DEVELOPMENT REVIEW COMMITTEE (DRC) COMMENT REPORT

PROJECT NAME: Startup Club

CASE NUMBER: R18035

REQUEST: Site Plan Level II Review: 5,196 Square-Foot Building Renovation within 100 Feet of Residential Property in Northwest Regional Activity Center

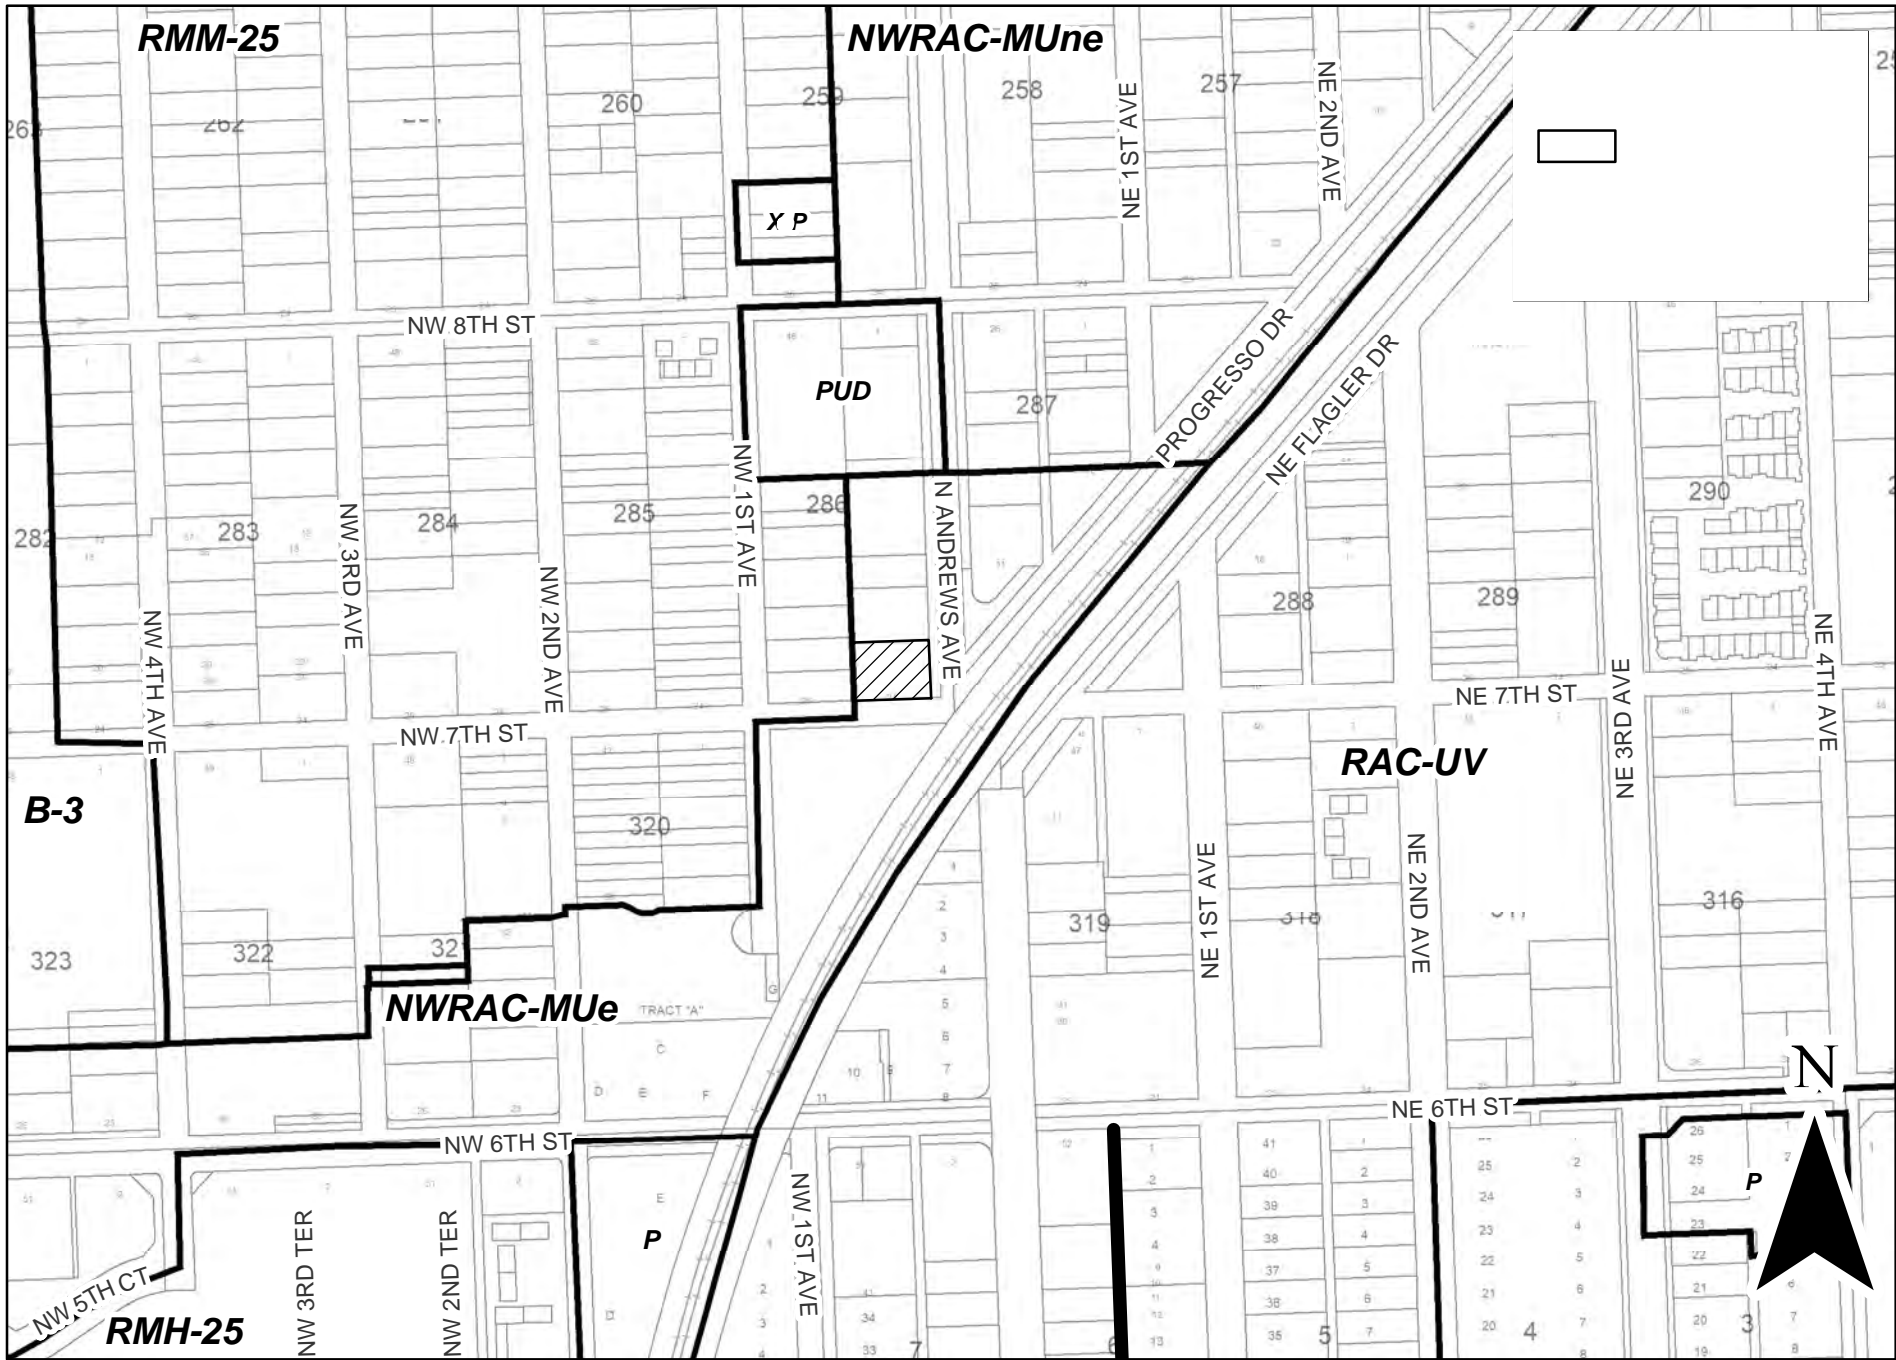
The project is within the NWRAC Master Plan – NWRAC Mixed Use East District (NWRAC-MUe) which is subject to the NWRAC Illustrations of Design Standards and building form, streetscape design, and overall project presence is important in creating a walkable, mixed-use neighborhood. Provide a rendering, at street level, pedestrian-level view for the project.

8. Provide the following changes on site plan:
 - a. Relocate the building line to allow for minimum 7 foot sidewalk and landscape buffer along N Andrews Avenue and NW 7th Street;
